**TECHNICAL BULLETIN**  
***Bell* Helicopter**  
A Textron Company

No. 205B-09-32

**SUBJECT:** TAIL ROTOR GEARBOX EXCLUDER HOUSING  
LEAK: PREVENTION OF

**Figure 1**

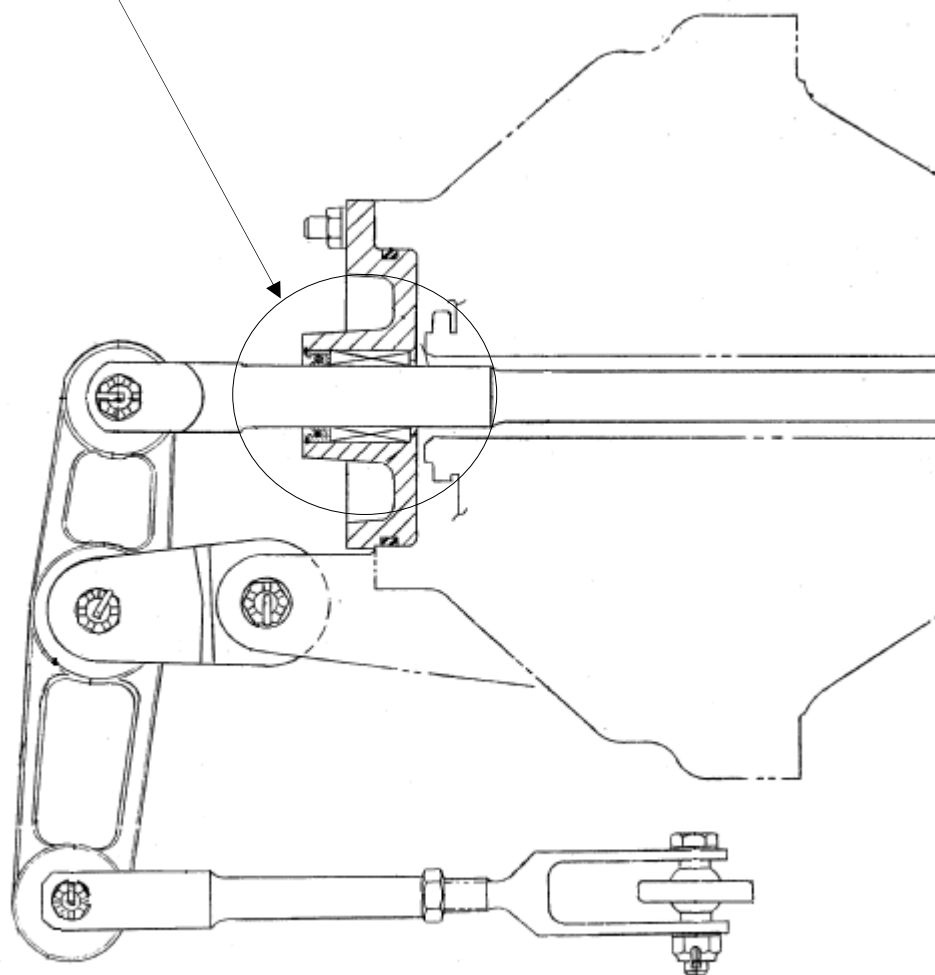
1. Make helicopter ready for maintenance.
2. Refer to Figures 1 and 2. Remove retaining ring (1) and extract excluder housing (2) by applying pressure on the tail rotor controls from full right pedal to full left. (IF excluder and packing need to be replaced refer to BHT-205-MM for disassembly instructions).
3. Using a clean cloth dampened with acetone (C-316) clean inside diameter of pitch change housing (3) where excluder housing (2) will be installed.
4. Using a clean cloth clean outside diameter of excluder housing (2) with acetone (C-316) and coat with sealant (C-328).
5. Install excluder housing (2) in pitch change housing (3).
6. Using a clean cloth dampened with acetone (C-316) remove excessive sealant and reinstall retaining ring (1).
7. Make an entry in helicopter historical records indicating compliance with this technical bulletin.

Figure 2

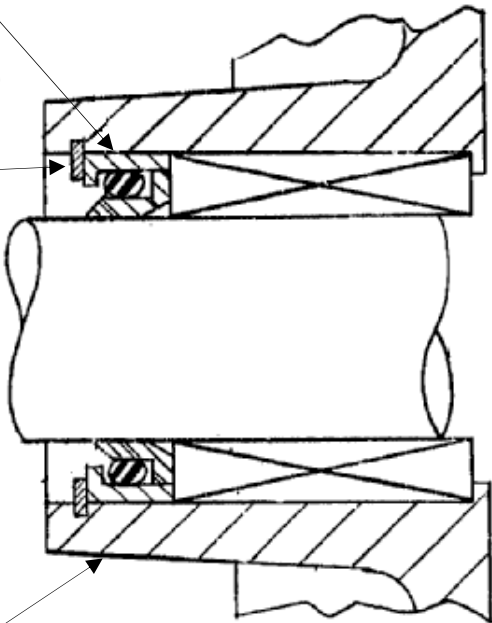
Refer to  
Figure 2
